#### **Process Sheet**

: PANEL-350 UPPER BULKHEAD

: D36553

FW: NCR D3655-3

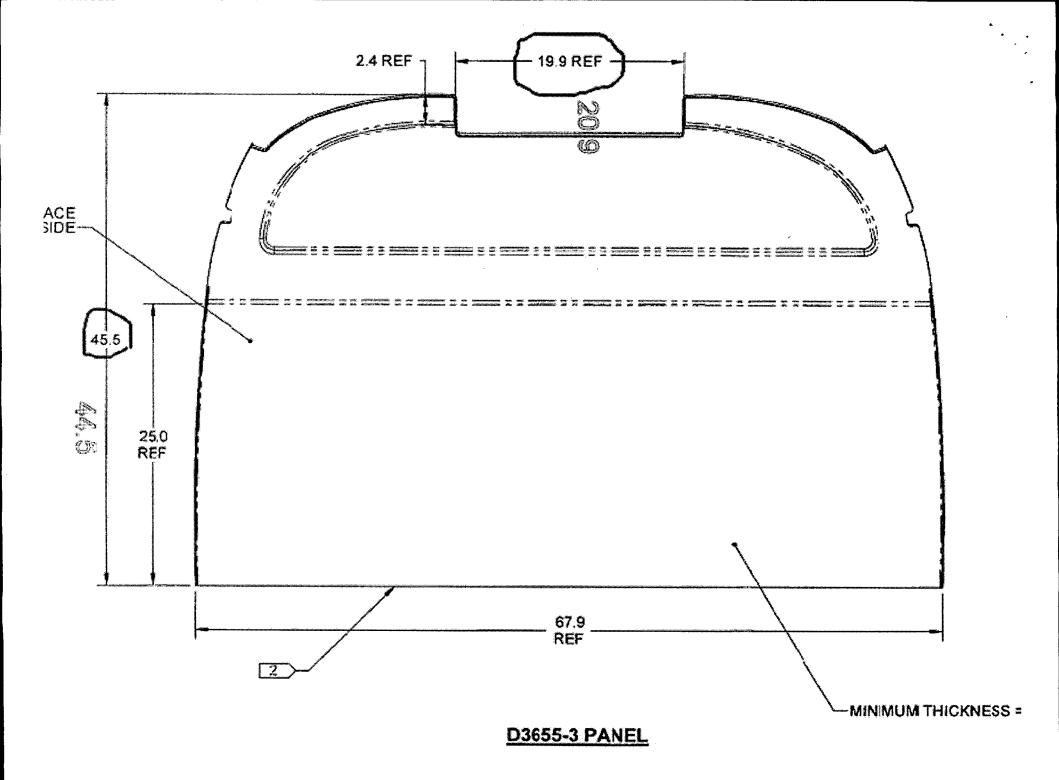
For the D3655-3 Panel (350 interiors), the dwg dimension 19.9" is 20.9", dwg dimension 45.5" is 44.5". Ref attached pic. The part was made to the mold. The dwg was evidently created before the mold, and the dimensions were never updated.

The 20.9" width of the 'slot' fits with the mating part correctly; 19.9" would be too small and would have a sloppy fit. A verified this myself.

The dwg length of 45.5" is impossible to achieve from the mold. Daryl made the part as long as possible. The parts have evidently been fit into the aircraft and I'm told this dim works.

The dwg obviously needs an update. In the meantime, can we accept this deviation?

If the parts match what is in the aircraft, they will be acceptable. But I don't think we should make any more without doing a PROPER FAI and checking against the drawing.
